HCRC has the following comments with regard to the applicant's 28 January 2020 Flood Risk Technical Note.

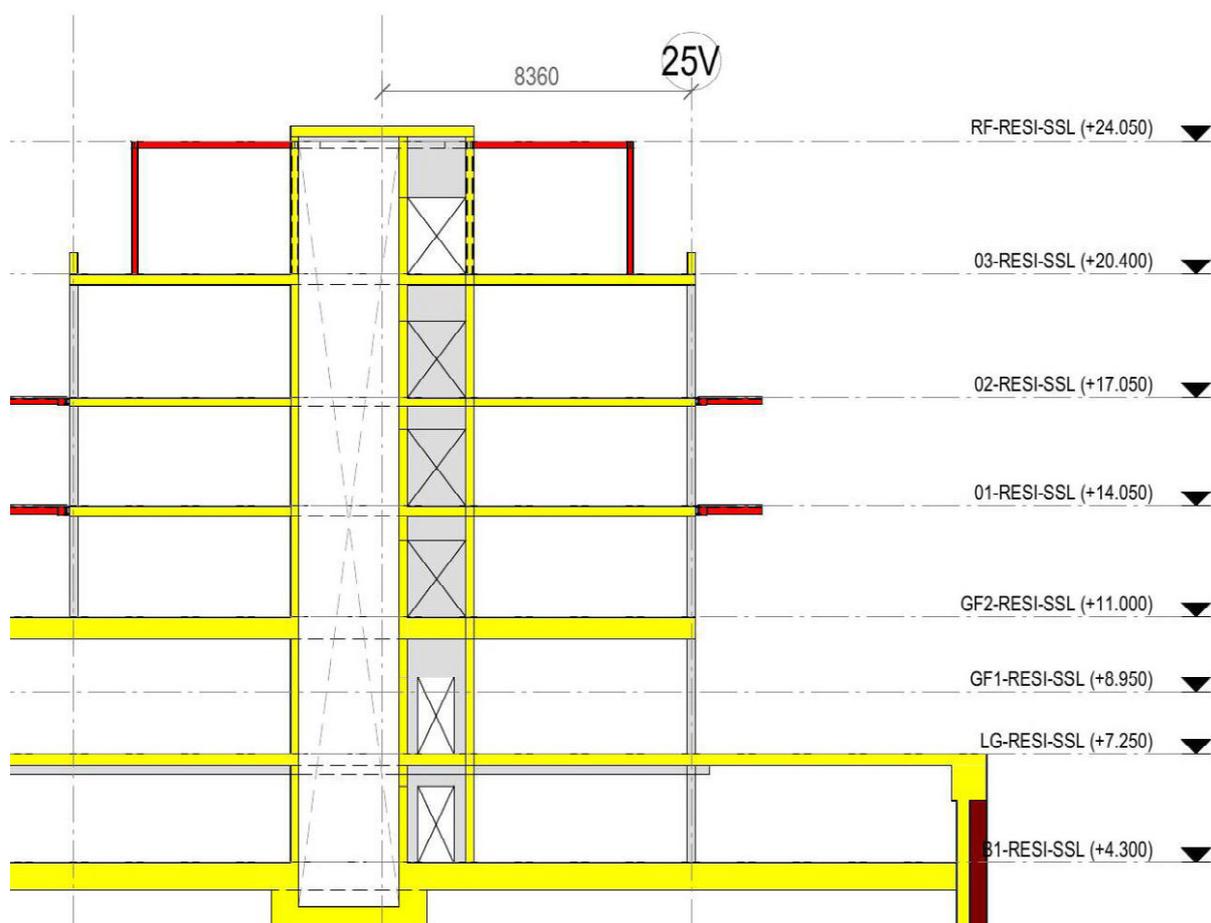
We note that Watermans have included a number of 2D and 3D drawings in Appendix C (for example, see below), none of which have to date been included in this application. Watermans have provided a very cursory explanation for these drawings.

The drawings are illustrative and make a significant contribution by clearly illuminating a number of characteristics of the scheme, some of which are less than positive. These include the number of storeys visible from Cigarette Island Park (CIP). We note land levels in CIP adjacent to the site range from 7.4m AOD to 7.6m AOD and the base level for the ground floor is 7.25m AOD. This drawing puts to bed any notion that this development is anything other than five storeys.

The 2D and 3D drawings are illustrative and fundamental to the application and should be added to the scheme portfolio of drawings and consulted on separately and not discreetly tucked away in a technical flood risk assessment update which few will read.
